**RE: RESPONSES TO SPECIFIC COMMENTS INCLUDED IN CDPHE RFI #4**
**PIÑON RIDGE PROJECT, MONTROSE COUNTY, COLORADO**

Golder Associates Inc. (Golder) has prepared this letter to provide responses to comments from the Colorado Department of Public Health and Environment (CDPHE) in the Request for Information (RFI) #4 as provided in the letter from Steve Tarlton dated 21 September 2010. This letter addresses specific comments included as Attachment 1 to RFI #4 prepared by Mr. Clay Trumpolt, and the comment from Mr. Larry Bruskin included as Attachment 2 to RFI #4.

**Figure 1: Phase 1 tailings deposition.**

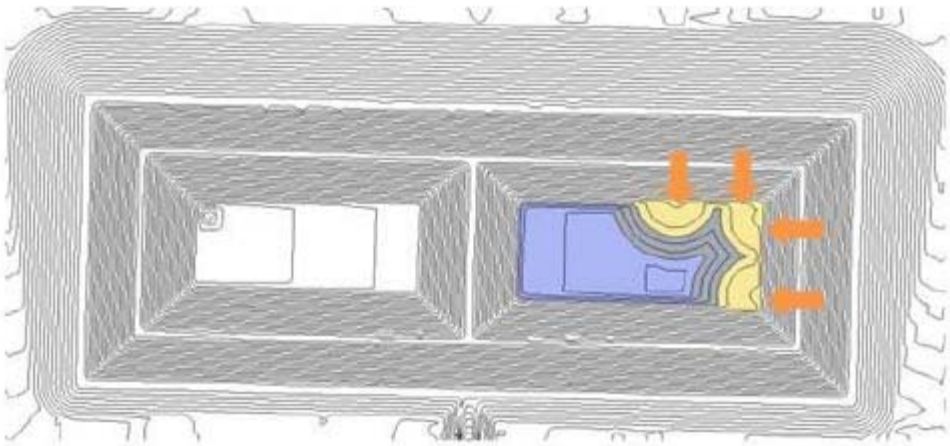
*Please provide a short narrative of how the spigots would be operated for the first tailings cell under normal operating conditions.*

- Phase 1 – Deposition commences within sub-cell A1 (or A2) in the vicinity of the underdrain sump to provide approximately 10 feet of tailings deposition over the sump area. This phase of deposition is illustrated conceptually in Figure 1, showing four (4) spigot points. This phase of deposition provides coarse-grained underflow tailings over the underdrain sump to enhance the long-term effectiveness of the tailings underdrain system;
